**SUNDRY NOTICES AND REPORTS ON WELLS**  
*Do not use this form for proposals to drill or to re-enter an abandoned well. Use Form 3160-3 (APD) for such proposals.*

2. Name of Operator  
Trinity Environmental SWD LLC

8. Well Name and No.  
Oxy Doc Stawin Fed #1

9. API Well No.  
30-015-33180

# Current Wellbore

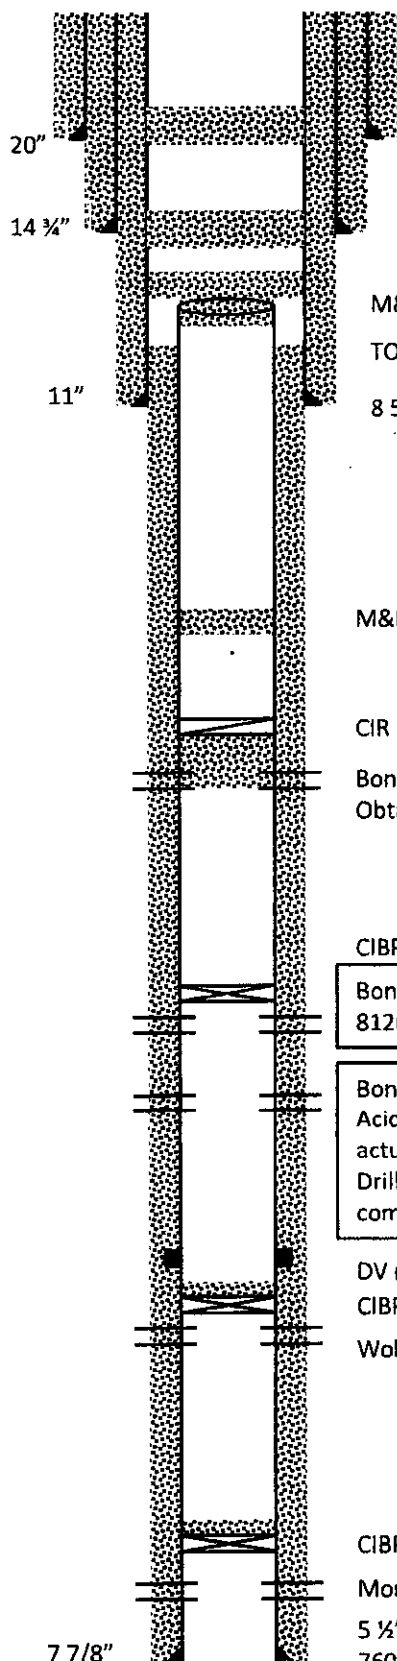
Operator will NU a 9" 3K BOPE on the 8 5/8" x 11" 3K starter head. This BOP will only be used to tie back the 5 1/2" casing that was cut off at 3000'. The BOP and related equipment will be tested to 1500 psi against the casing and surface plug, prior to drilling out the surface plug. Once the 5 1/2" casing has been tied back, a 7 1/16" SK BOP will be nipped up per the APD and tested per Onshore 2.

As a contingency, if a water flow is encountered after drilling the Wolfcamp plug at 8992', the 200' cement plug that was to be set over the Morrow per the APD will be replaced with a CIBP @ 11175' and capped with 35' of cement. Per Onshore 2.III.G.2, in lieu of a cased hole cement plug, a bridge plug is acceptable provided the bridge plug is capped with 35' of cement if a bailer is used.
